CASE # 18026
RELATED CASE # 9-27-92
REVISED DISTRICT DEVELOPMENT PLAN

OF
KAMERI AUTO SERVICE CENTER
800 OUTER LOOP
LOUISVILLE, KENTUCKY 40214

REVISED DISTRICT DEVELOPMENT PLAN

KAMERI AUTO SERVICE CENTER

PRELIMINARY APPROVAL DEVELOPMENT PLAN

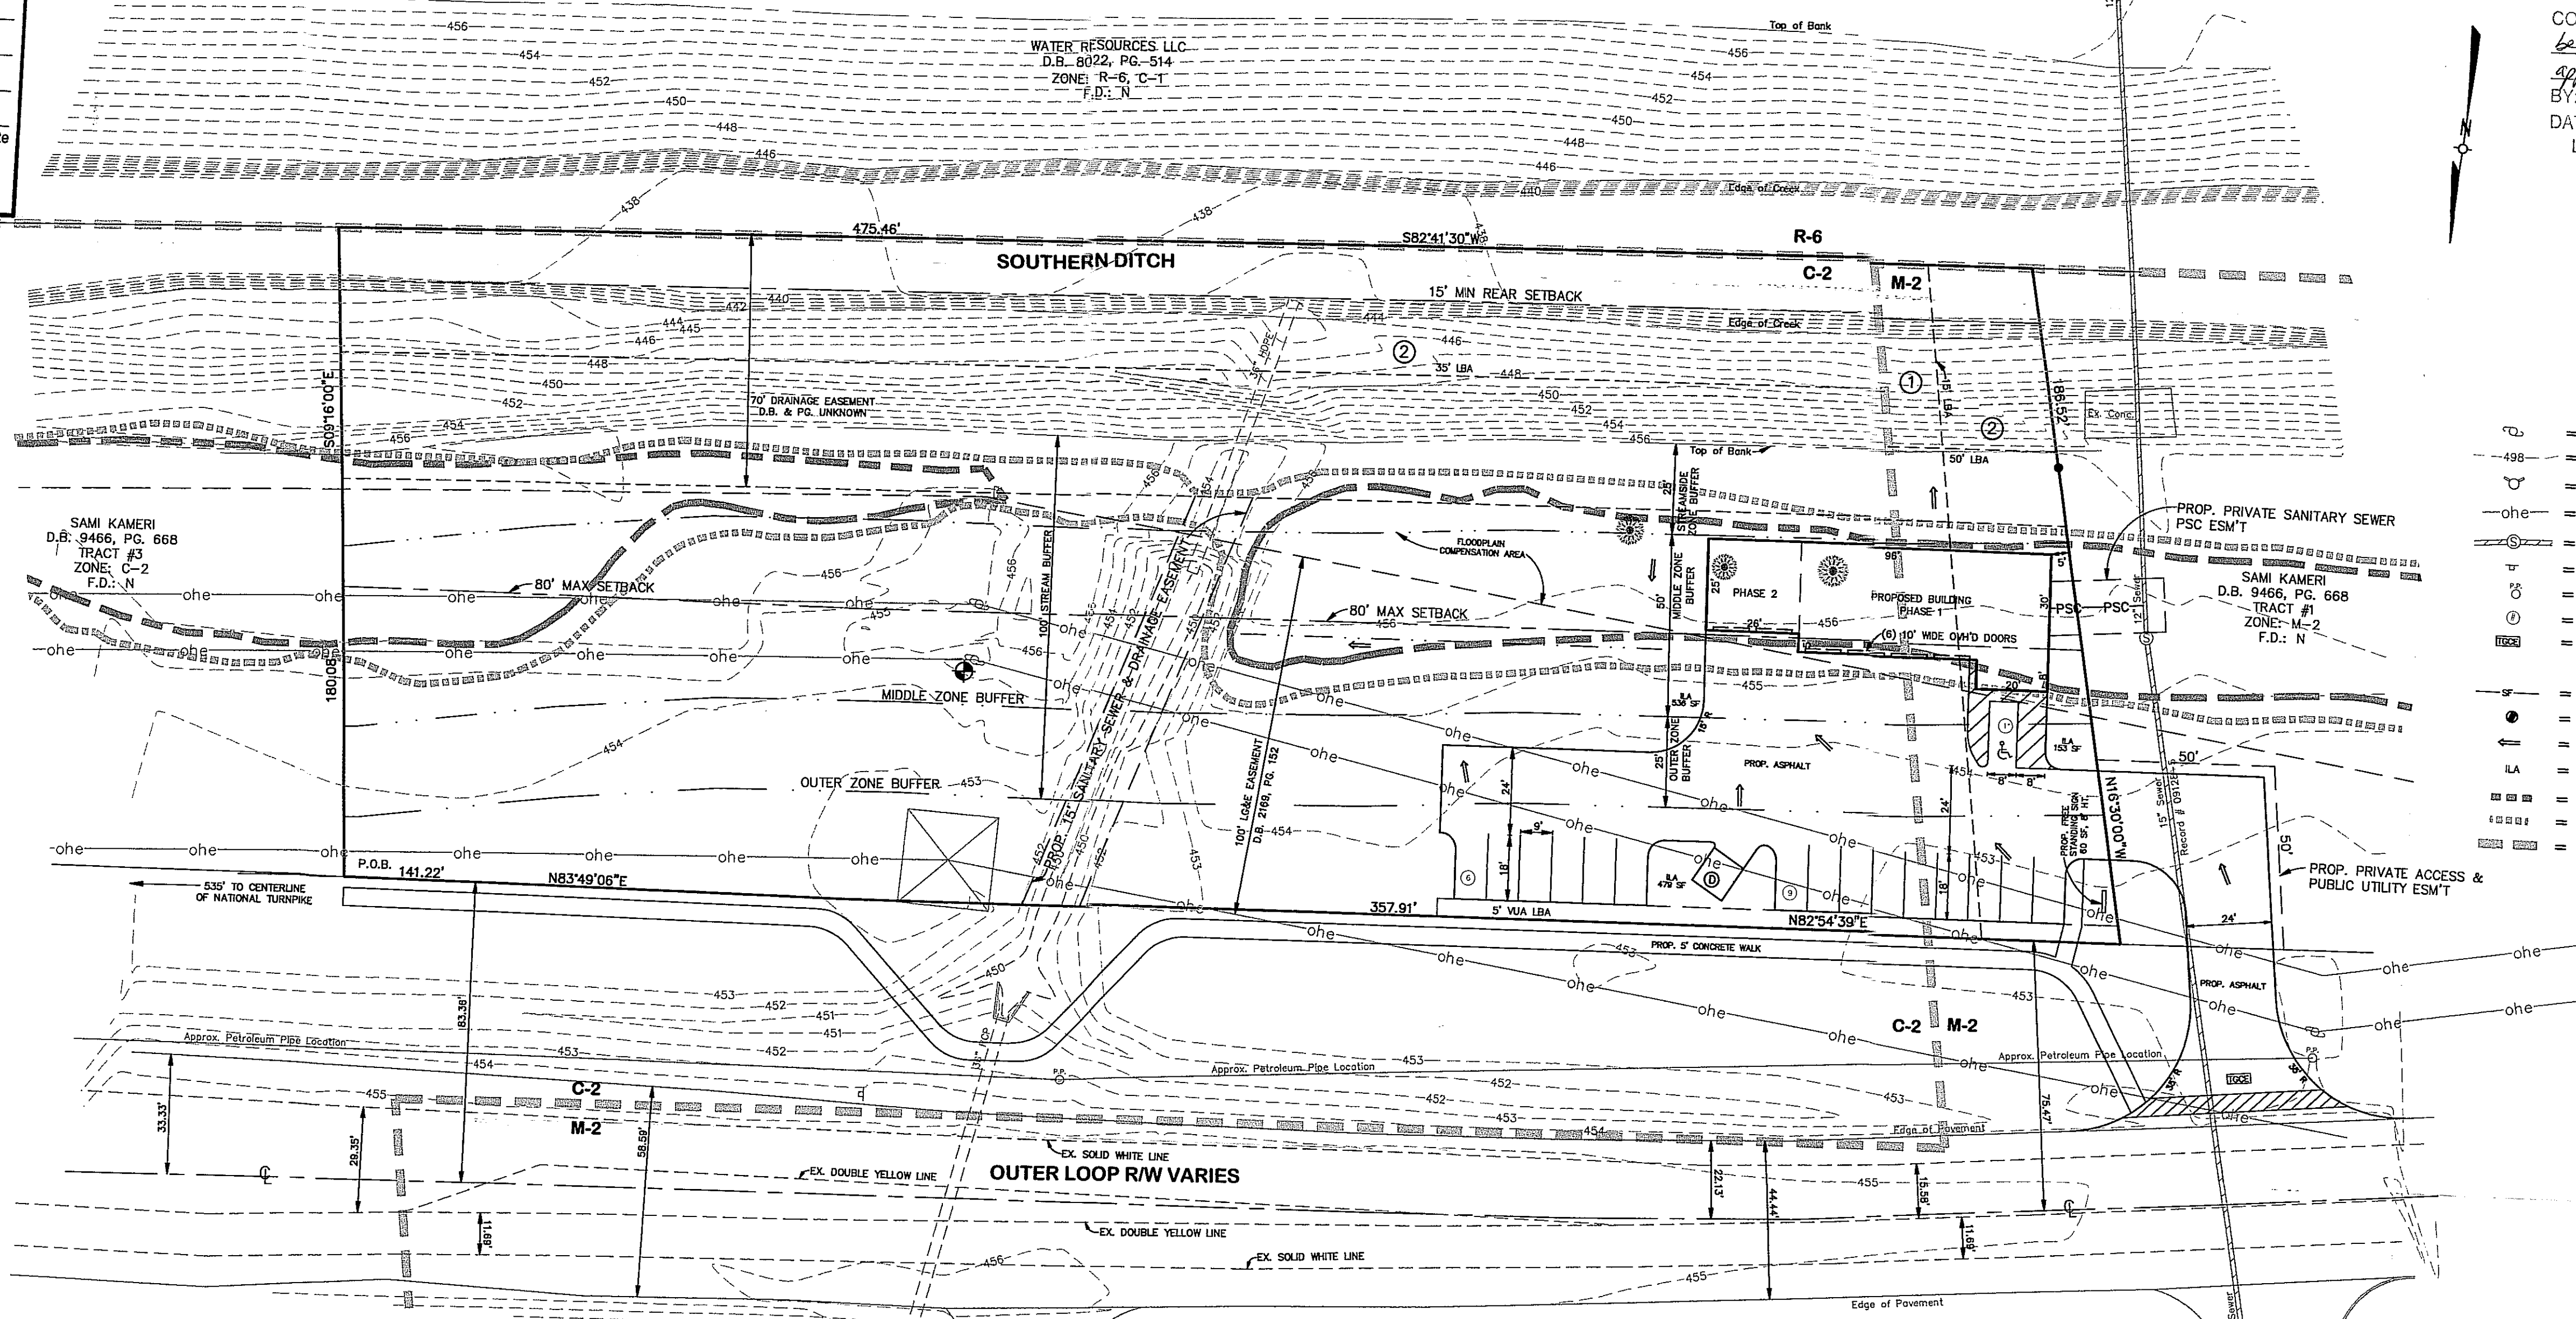
CONDITIONS: *Revised easement needs to be recorded prior to construction*
